DEVELOPMENT NO.:	25029569
APPLICANT:	Scott Bell
ADDRESS:	54 BUTTROSE ST GLENELG EAST SA 5045
NATURE OF DEVELOPMENT:	Two level detached dwelling, outbuilding and swimming pool
ZONING INFORMATION:	Zones: • Established Neighbourhood Overlays: • Airport Building Heights (Regulated) • Affordable Housing • Building Near Airfields • Character Area • Hazards (Flooding - General) • Prescribed Wells Area • Regulated and Significant Tree • Stormwater Management • Urban Tree Canopy Technical Numeric Variations (TNVs): • Minimum Frontage (Minimum frontage for a detached dwelling is 14m; semi-detached dwelling is 14m) • Minimum Site Area (Minimum site area for a detached dwelling is 600 sqm; semi-detached dwelling is 600 sqm) • Maximum Building Height (Levels) (Maximum building height is 1 level)
LODGEMENT DATE:	22 Sept 2025
RELEVANT AUTHORITY:	Council Assessment Panel
PLANNING & DESIGN CODE VERSION:	P&D Code (in effect) Version 2025.17 11/09/2025

CATEGORY OF DEVELOPMENT:	Code Assessed - Performance Assessed
NOTIFICATION:	Yes
RECOMMENDING OFFICER:	Dean Spasic Development Officer - Planning

Boundary Setbacks

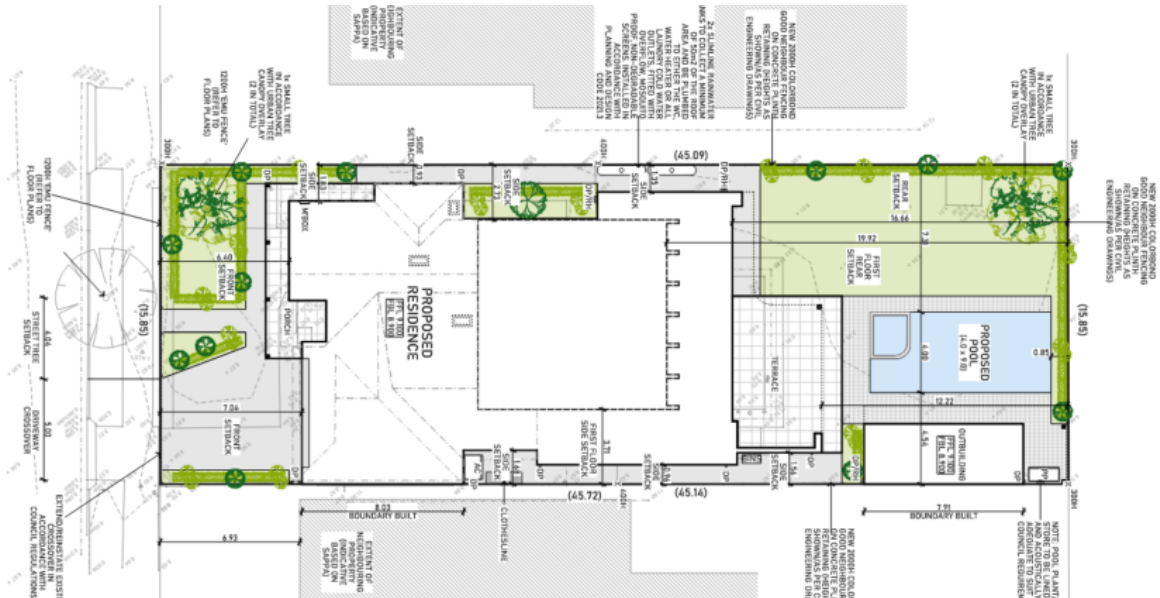
The building is setback 6.4 to 7 metres from the primary street boundary, which is complementary to the existing streetscape. The building is slightly forward of the average neighbouring building setback (6.95 metres) however on balance, the 550mm front setback variance concerning a 4.7 metre wide element of the facade is negligible.

The garage wall is located on the southern side boundary with a height of 2.7 metres over a length of 8 metres, which is within the Design Code parameters of 3.2 metres height and 8 metres length.

The ground level walls are up to 3.3 metres high and setback at least 930mm from side boundaries. According to Designated Performance Feature 8.1 pertaining to side boundary setbacks, the minimum side boundary setback should be in the range of 1 metre. the 70mm variance is deemed to be negligible with respect to light and ventilation considerations.

The upper level wall is 7.3 metres high and setback 2.7 metres from the northern side boundary and 3.7 metres from the southern side boundary. According to the Designated Performance Feature 8.1 pertaining to side boundary setbacks, the upper level wall should be setback at least 2.3 metres from the northern side boundary and 3.3 metres from the southern side boundary, to which both minimum distances are achieved.

At the ground level, the building is setback 16.6 metres and at the upper level 19.9 metres from the rear boundary, which satisfies the Designated Performance Feature 9.1 which anticipates a setback of 4 and 6 metres respectively.

Private Open Space

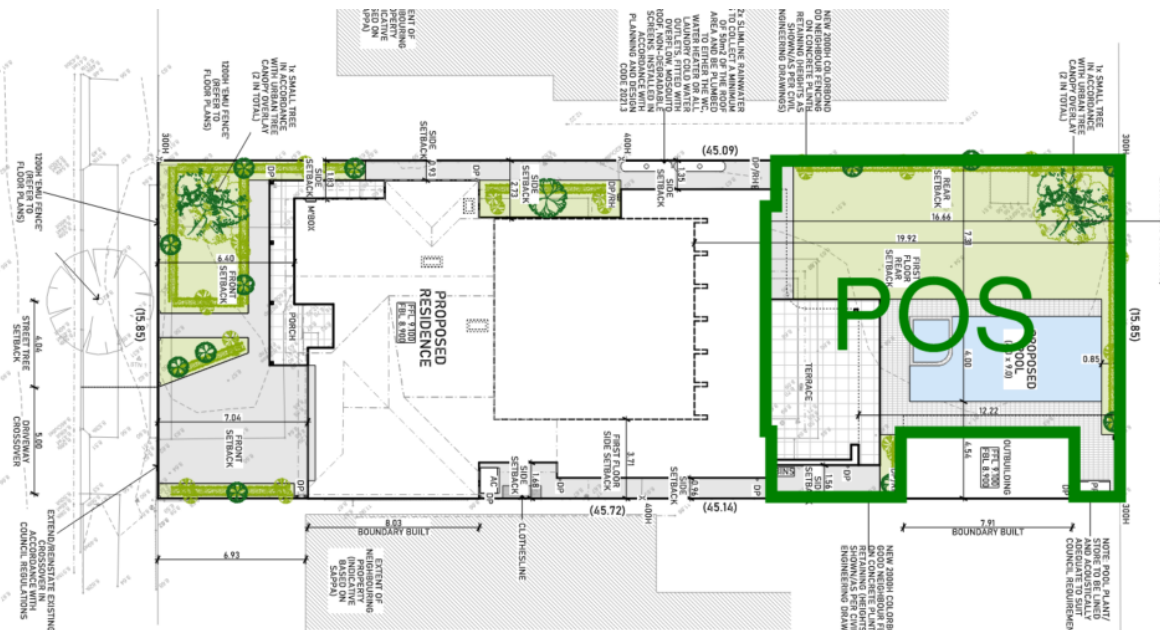
The proposal accommodates a private open space area of some 236 square metres, directly accessible from a living space, and substantially exceeding the minimum of 60 square metres sought by the Design Code.

Site Coverage

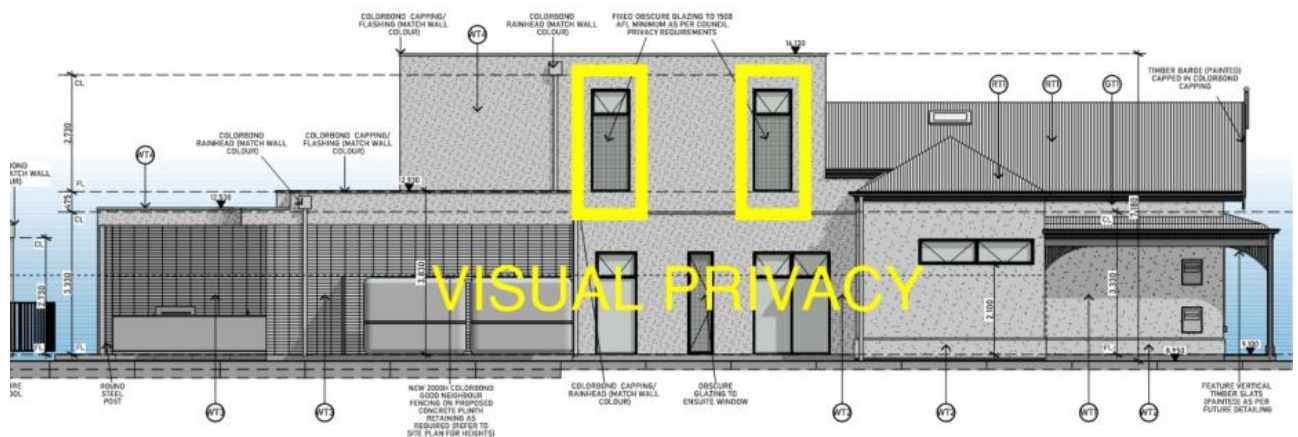
Site coverage amounts to 50 percent of the site area, which satisfies the maximum of 50 percent anticipated by Designated Performance Feature 3.1.
